COUNTY OF LOS ANGELES DEPARTMENT OF PUBLIC WORKS

**DEVELOPMENT SERVICES CORE SERVICE AREA
PROPOSED ORDINANCES – 2023 LOS ANGELES COUNTY
BUILDING, ELECTRICAL, PLUMBING, MECHANICAL, RESIDENTIAL,
GREEN BUILDING STANDARDS, AND EXISTING BUILDING CODES
(ALL SUPERVISORIAL DISTRICTS)
(3 VOTES)**

An ordinance amending Title 26 – Building Code – of the Los Angeles County Code, to adopt and incorporate by reference the 2022 California Building Code, with certain changes and modifications, and to make other revisions thereto.

FIGURE 1809.3

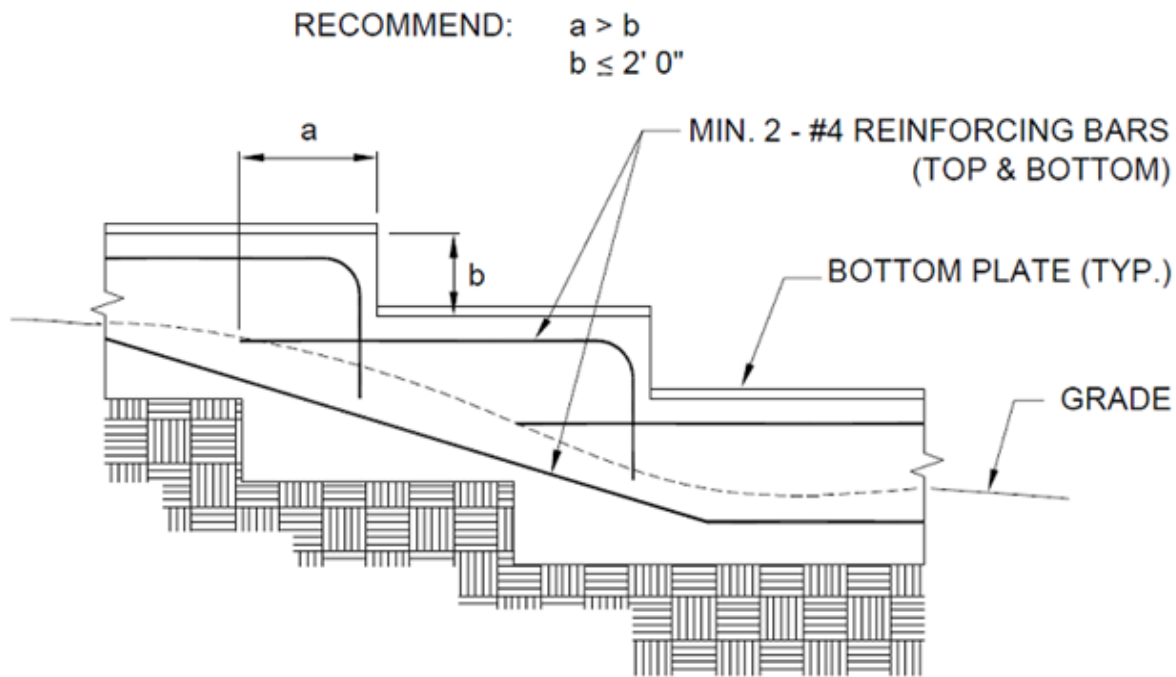
For structures assigned to Seismic Design Category D, E, or F, the stepping requirement shall also apply to the top surface of continuous footings supporting walls. Footings shall be reinforced with four No. 4 reinforcing bars. Two bars shall be located at the top and bottom of the footings as shown in Figure 1809.3.

SECTION 33. Figure 1809.3 is hereby added to read as follows:

1809.3 and Figure 1809.3	Geological	With the higher seismic demand placed on buildings and structures in this region, it is necessary to take precautionary steps to reduce or eliminate potential problems that may result for under-reinforced footings located on sloped surfaces. Requiring minimum reinforcement for stepped footings is intended to address the problem of poor performance of plain or under-reinforced footings during a seismic event. This amendment is a continuation of an amendment adopted during previous code adoption cycles.
1809.7 and Table 1809.7	Geological	No substantiating data has been provided to show that under-reinforced footings are effective in resisting seismic loads, and therefore they may potentially lead to a higher risk of failure. This amendment requires minimum reinforcement in continuous footings to address the problem of poor performance of plain or under-reinforced footings during a seismic event. With the higher seismic demand placed on buildings and structures in this region, it is necessary to take precautionary steps to reduce or eliminate potential

**FIGURE 2308.6.5.1
ALTERNATE BRACED WALL PANEL (ABW)**

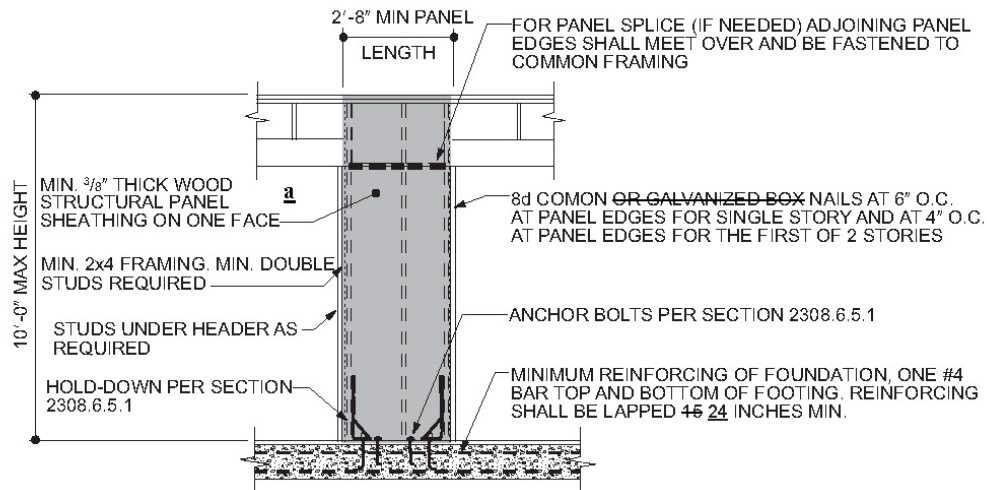
An ABW shall be constructed in accordance with this section and Figure 2308.6.5.1. In one-story buildings, each panel shall have a length of not less than 2 feet 8 inches (813 mm) and a height of not more than 10 feet (3048 mm). Each panel shall be sheathed on one face with 3/8-inch (3.2 mm) minimum-thickness wood structural panel sheathing nailed with 8d common or galvanized box nails in accordance with Table 2304.10.1 and blocked at wood structural panel edges. For structures assigned to Seismic Design Category D or E, each panel shall be sheathed on one face with 15/32-inch minimum-thickness (11.9 mm) wood structural panel sheathing nailed with 8d common nails spaced 3 inches on panel edges, 3 inches at intermediate supports. Two anchor bolts installed in accordance with Section 2308.3.1 shall be provided in each panel. Anchor bolts shall be placed at each panel outside quarter points. Each panel end stud shall have a hold-down device fastened to the foundation, capable of providing an approved uplift capacity of not less than 1,800 pounds (8006 N). The hold-down device shall be installed in accordance with the manufacturer's recommendations. The ABW shall be supported directly on a foundation or on floor framing supported directly on a foundation that is continuous across the entire length of the braced wall line. This foundation shall be reinforced with not less than one No. 4 bar top and bottom. Where the continuous foundation is required to have a depth greater than 12 inches (305 mm), a minimum 12-inch by 12-inch (305 mm by 305 mm) continuous footing ~~or turned-down slab edge~~ is permitted at door openings in the braced

SECTION 54. Figure 2308.6.5.1 is hereby amended to read as follows:

2306.2 2306.3 2307.2 2308.6.5.1 2308.6.5.2 Figure 2308.6.5.1 and Figure 2308.6.5.2	Geological	<p>The SEAOSC and the Los Angeles City Joint Task Force that investigated damage to buildings and structures during the 1994 Northridge Earthquake recommended reducing allowable shear values in wood structural panel shear walls or diaphragms that were not substantiated by cyclic testing. That recommendation was consistent with a report to the Governor from the Seismic Safety Commission of the State of California recommending that code requirements be "more thoroughly substantiated with testing." The allowable shear values for wood structural panel shear walls or diaphragms fastened</p>

**FIGURE 2308.6.5.2
PORTAL FRAME WITH HOLD-DOWNS (PFH)**

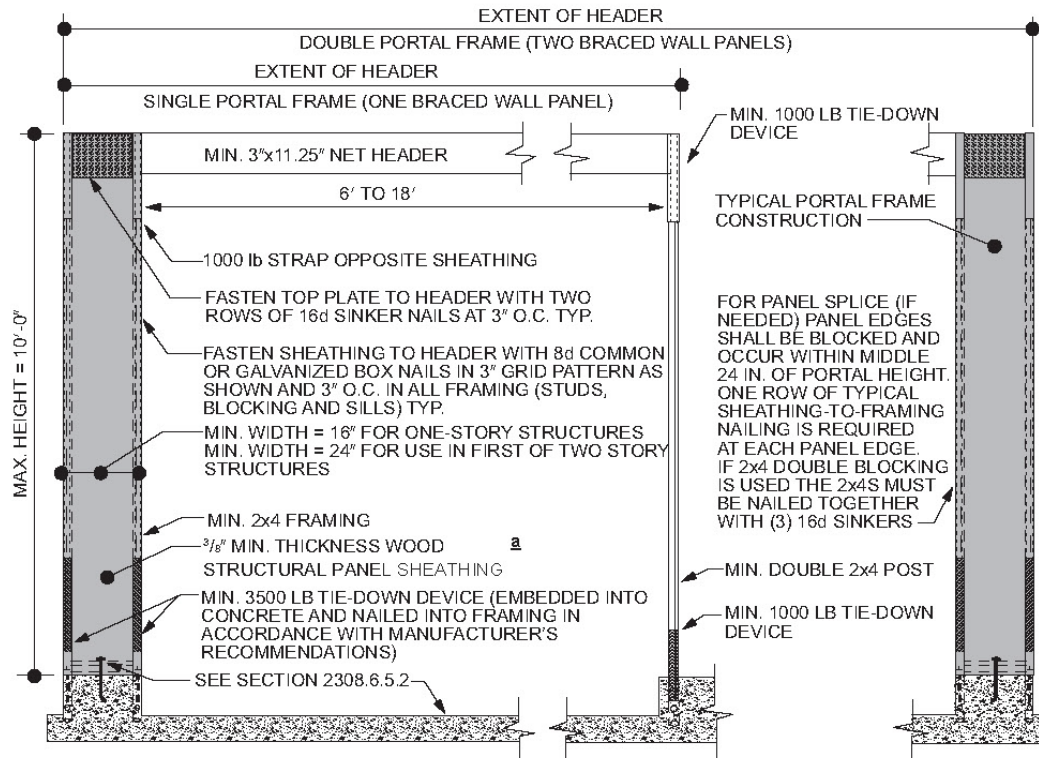
structural panel sheathing nailed with 8d common or galvanized box nails in accordance with Figure 2308.6.5.2. For structures assigned to Seismic Design Category D or E, each panel shall be sheathed on one face with 15/32-inch minimum-thickness (11.9 mm) wood structural panel sheathing nailed with 8d common nails spaced 3 inches on panel edges, 3 inches at intermediate supports and in accordance with Figure 2308.6.5.2. The wood structural panel sheathing shall extend up over the solid sawn or glued-laminated header and shall be nailed in accordance with Figure 2308.6.5.2. A built-up header consisting of at least two 2-inch by 12-inch (51 mm by 305 mm) boards, fastened in accordance with Item 24 of Table 2304.10.1 shall be permitted to be used. A spacer, if used, shall be placed on the side of the built-up beam opposite the wood structural panel sheathing. The header shall extend between the inside faces of the first full-length outer studs of each panel. The clear span of the header between the inner studs of each panel shall be not less than 6 feet (1829 mm) and not more than 18 feet (5486 mm) in length. A strap with an uplift capacity of not less than 1,000 pounds (4,400 N) shall fasten the header to the inner studs opposite the sheathing. One anchor bolt not less than 5/8 inch (15.9 mm) diameter and installed in accordance with Section 2308.3.1 shall be provided in the center of each sill plate. The studs at each end of the panel shall have a hold-down device fastened to the foundation with an uplift capacity of not less than 3,500 pounds (15 570 N).

SECTION 56. Figure 2308.6.5.2 is hereby amended to read as follows:

FIGURE J108.1
DRAINAGE SETBACK DIMENSIONS

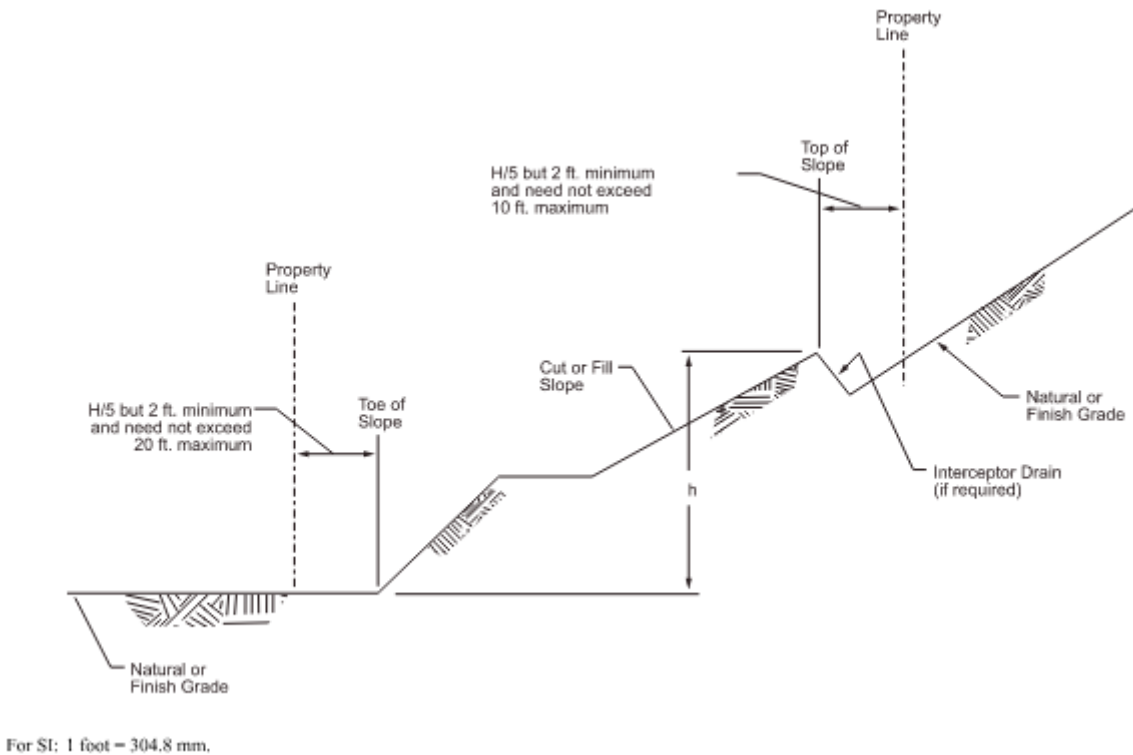
Cut and fill slopes shall be set back from the property lines in accordance with this ~~s~~Section. Setback dimensions shall be measured perpendicular to the property line and shall be as shown in Figure J108.1, unless substantiating data is submitted justifying reduced setbacks, and reduced setbacks are recommended in a geotechnical engineering and engineering geology report approved by the Building Official.

SECTION 78. Figure J108.1 is hereby amended to read as follows:

**FIGURE R403.1.5
STEPPED FOOTING**

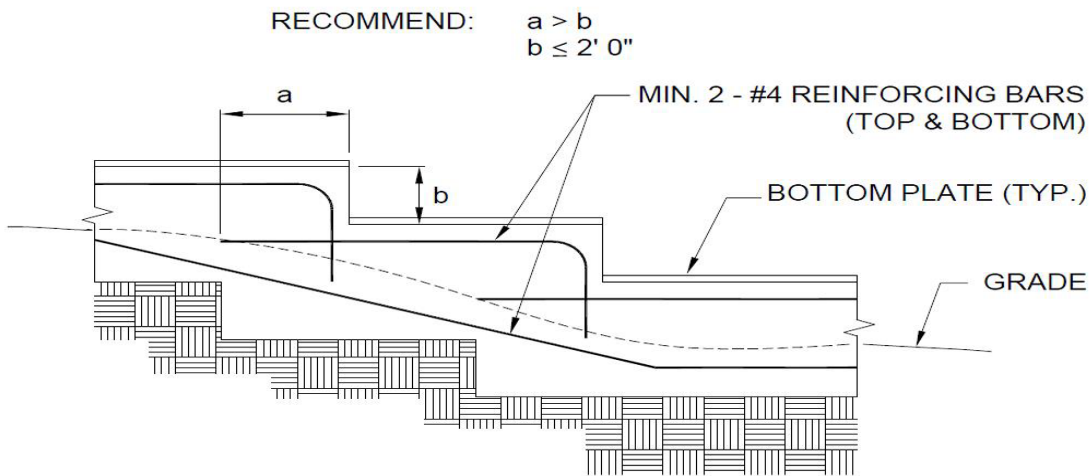
For structures located in Seismic Design Category D₀, D₁, or D₂, stepped footings shall be reinforced with two No. 4 reinforcing bars. Two bars shall be located at the top and bottom of the footings as shown in Figure R403.1.5.

SECTION 30. Figure R403.1.5 is hereby added to read as follows:

R403.1.2 R403.1.3.6 R403.1.5 Figure R403.1.5	Climatic Geological	<p>Los Angeles County is prone to seismic activity due to the existence of active faults in the Southern California area. These amendments require minimum reinforcement in continuous footings and stepped footings to address the problem of poor performance of plain or under-reinforced footings during a seismic event. These amendments implement the recommendations of SEAOSC and the Los Angeles City Joint Task Force resulting from their investigation of the 1994 Northridge Earthquake. Interior walls can easily be called upon to resist over half of the seismic loading imposed on simple buildings or structures. Without a continuous foundation to support the braced wall line, seismic loads would be transferred through other elements such as non-structural concrete slab floors, wood floors, etc. Requiring interior braced walls to be supported by continuous foundations is intended to reduce or eliminate the poor performance of buildings or structures.</p>

FIGURE R503.2.4

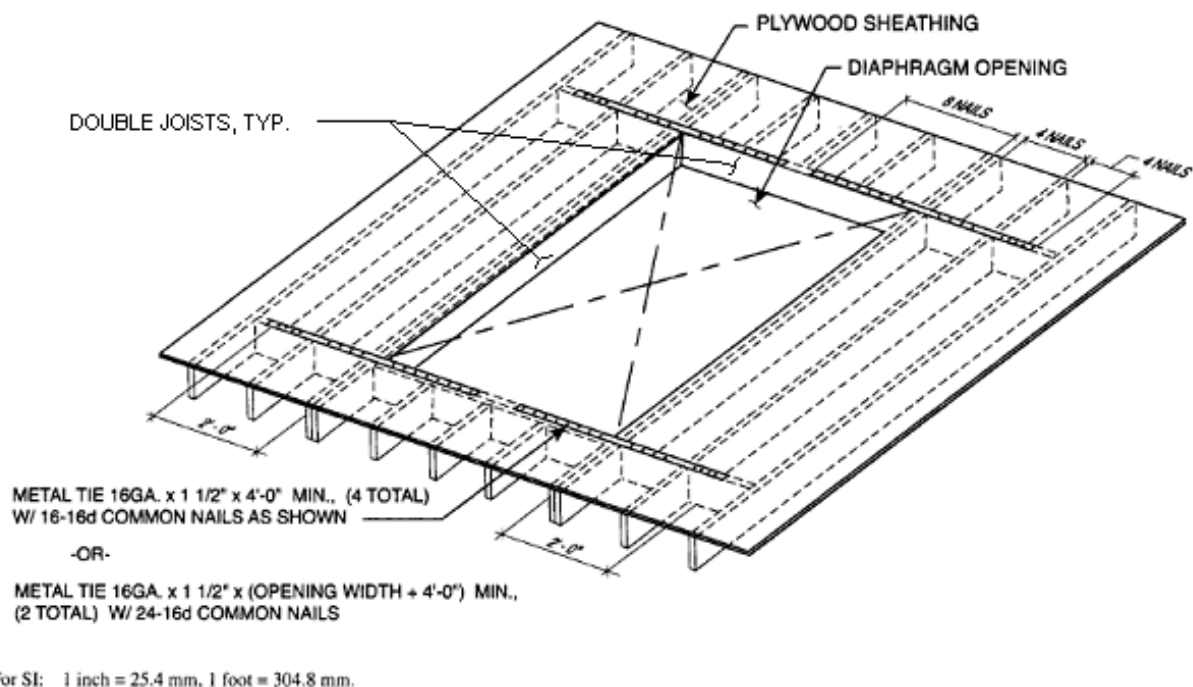
Openings in horizontal diaphragms with a dimension perpendicular to the joist that is greater than 4 feet (1.2 m) shall be constructed in accordance with Figure R503.2.4.

SECTION 34. Figure R503.2.4 is hereby added to read as follows:

**FIGURE R602.10.6.1
METHOD ABW—ALTERNATE BRACED WALL PANEL**

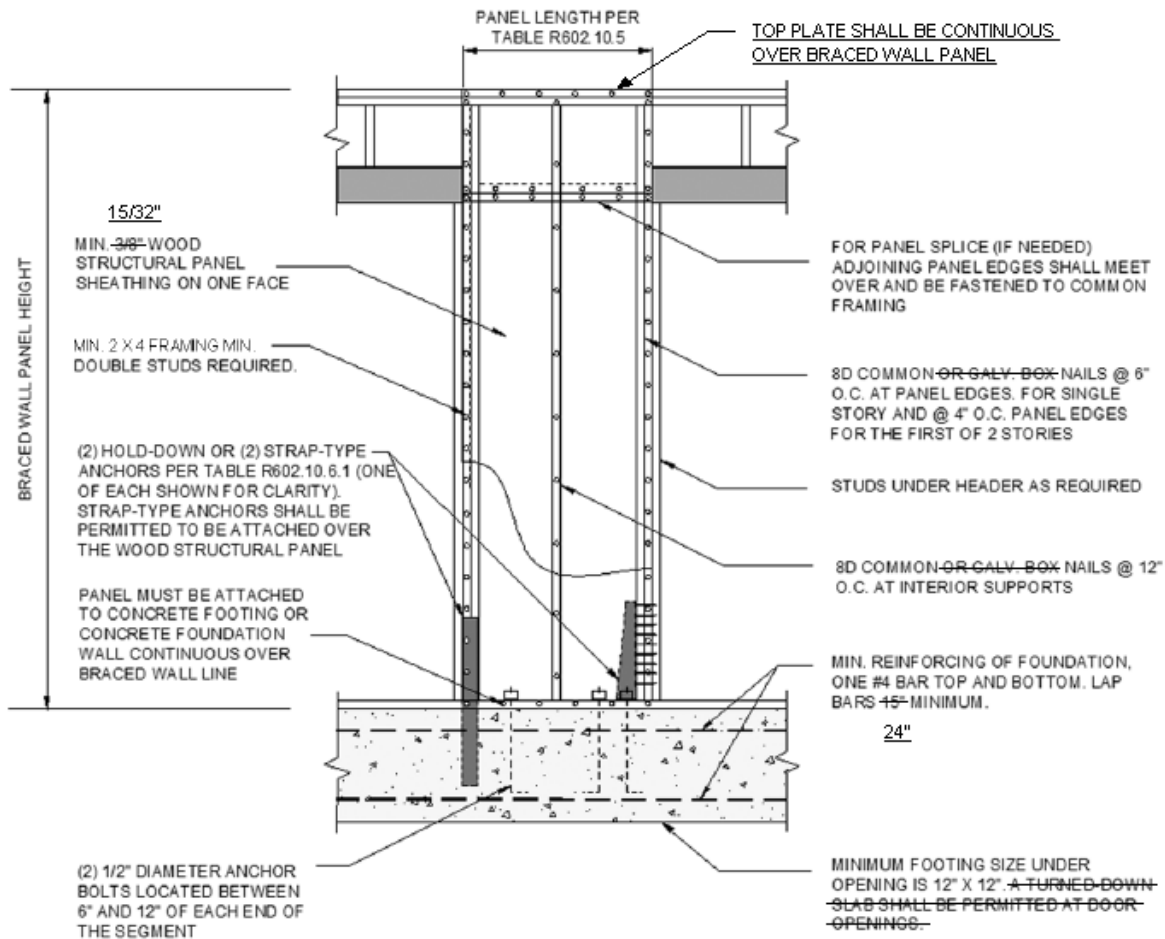
Figure R602.10.6.1 is amended to read as follows:

FIGURE R602.10.6.2
METHOD PFH—PORTAL FRAME WITH HOLD-DOWNS
AT DETACHED GARAGE DOOR OPENINGS

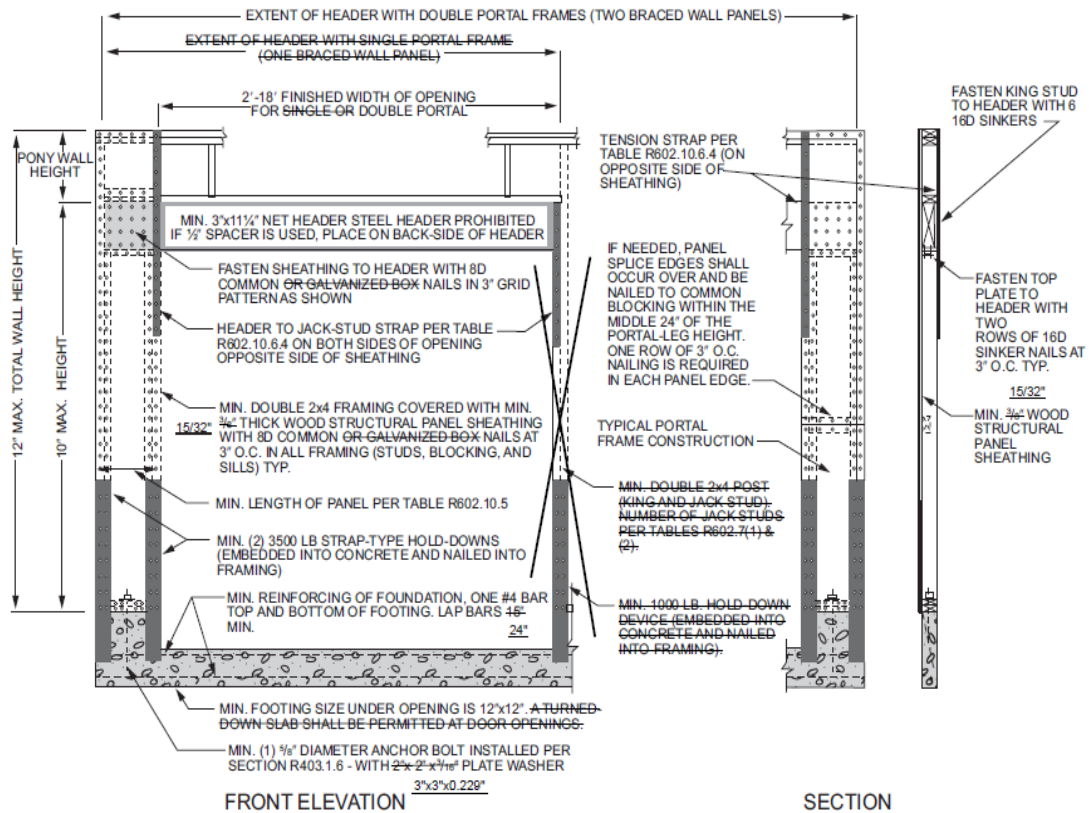
SECTION 44. Figure R602.10.6.2 is hereby amended to read as follows:

Figure R602.10.6.2	Geological	3/8" thick 3 ply-plywood shear walls experienced many failures during the Northridge Earthquake. The poor performance of such shear walls in the 1994 Northridge Earthquake was investigated by SEAOSC and the Los Angeles City Joint Task Force. The County of Los Angeles and cities in this region have taken extra measures to maintain the structural integrity of the framing of the shear walls when designed for high levels of seismic loads. Box nails were observed to cause massive and multiple failures of typical 3/8-inch thick plywood during the Northridge Earthquake. This change to the minimum lap splice requirement is consistent with Section 12.16.1 of ACI 318-11. This amendment is a continuation of amendments adopted during prior Code adoption cycles.

FIGURE R602.10.6.4
METHOD CS-PF—CONTINUOUSLY SHEATHED PORTAL FRAME PANEL CONSTRUCTION

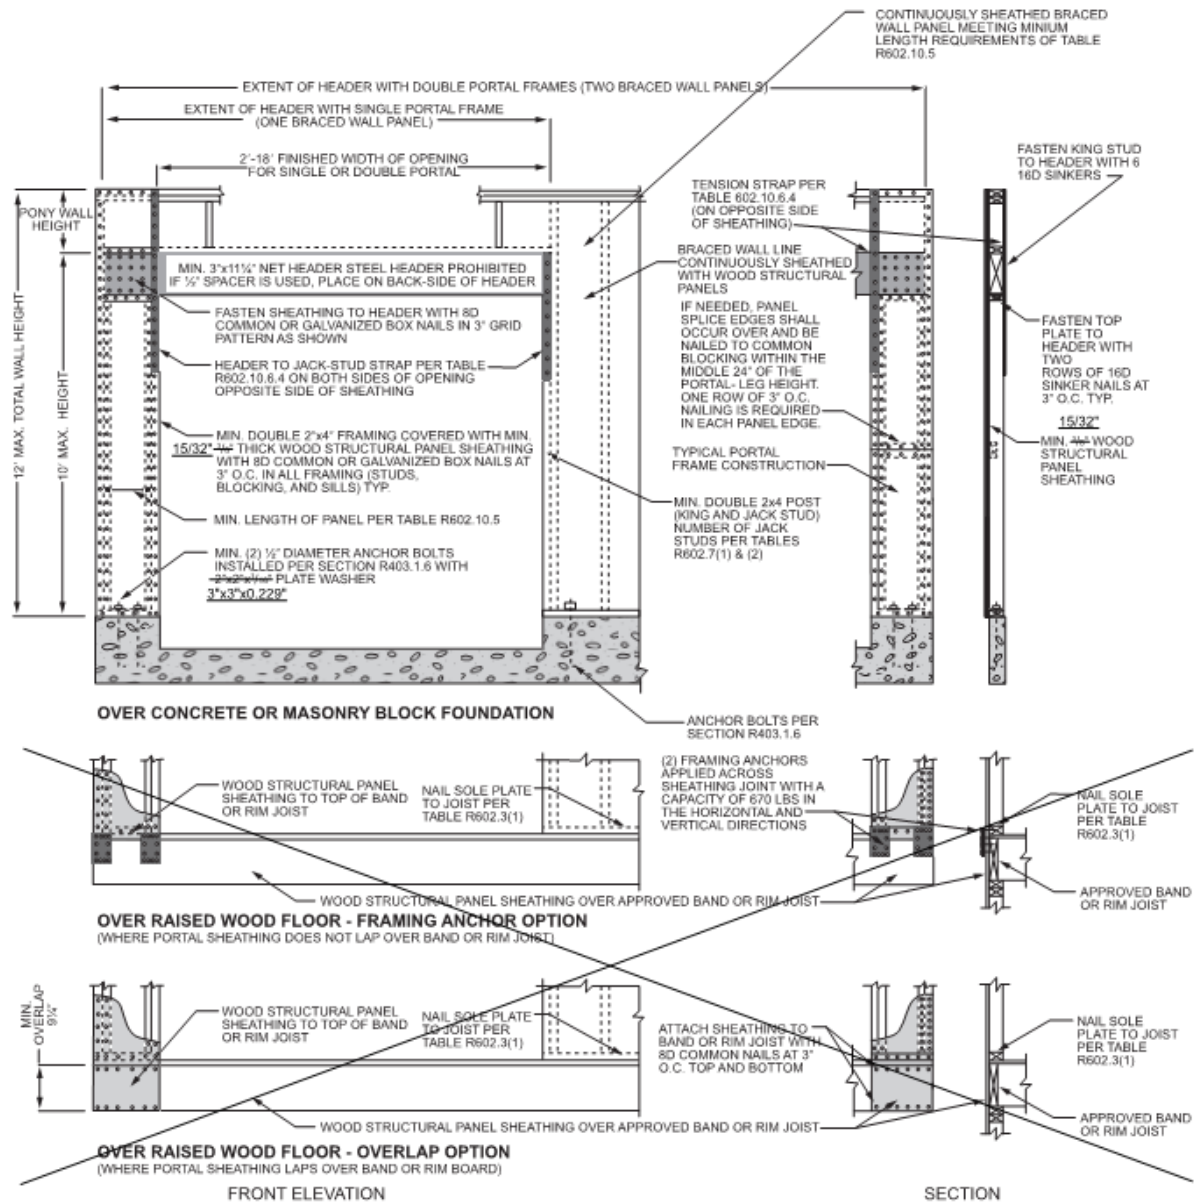
Figure R602.10.6.4 is hereby amended to read as follows:

Figure R602.10.6.4	Geological	3/8" thick 3 ply-plywood shear walls experienced many failures during the Northridge Earthquake. The poor performance of such shear walls in the 1994 Northridge Earthquake was investigated by SEAOSC and the Los Angeles City Joint Task Force. The County of Los Angeles and cities in this region have taken extra measures to maintain the structural integrity of the framing of the shear walls when designed for high levels of seismic loads. The proposal in which "washers shall be a minimum of 0.229 inch by 3 inches by 3 inches in size" is consistent with Section R602.11.1 of the California Residential Code and Section 2308.3.1 of the California Building Code. This amendment is a continuation of amendments adopted during prior Code adoption cycle.
R606.4.4	Geological	Los Angeles County is prone to seismic activity due to the existence of active faults in the Southern California area. The addition of the word "or" will prevent the use of unreinforced parapets in Seismic Design Category D ₀ , D ₁ , or D ₂ , or on townhouses in Seismic Design Category C.
